***Interactive comment on “Reliability of water distribution networks due to pumps failure: comparison of VSP and SSP application” by N. Mehzad et al.***

Responses of the authors to the reviewers' comments on the paper entitled “Reliability of water distribution networks due to pumps failure: comparison of VSP and SSP application” By N. Mehzad, M. Tabesh, S. S. Hashemi, and B. Ataee Kia

**Fig. 1.** The comparison of reliability of two type of pumps (VSP, SSP), with weighted average of four scenarios using three nodal pressure equations.

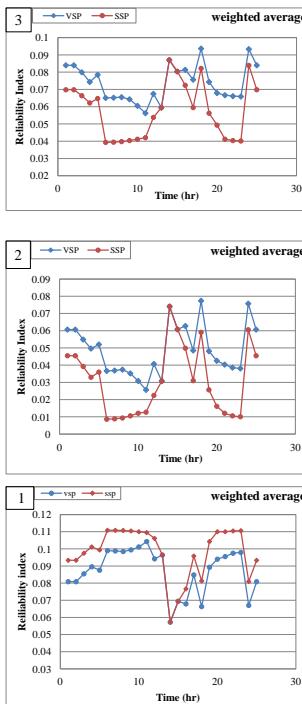
Appendix: figures in page 372  
should be replaced by these  
figures.
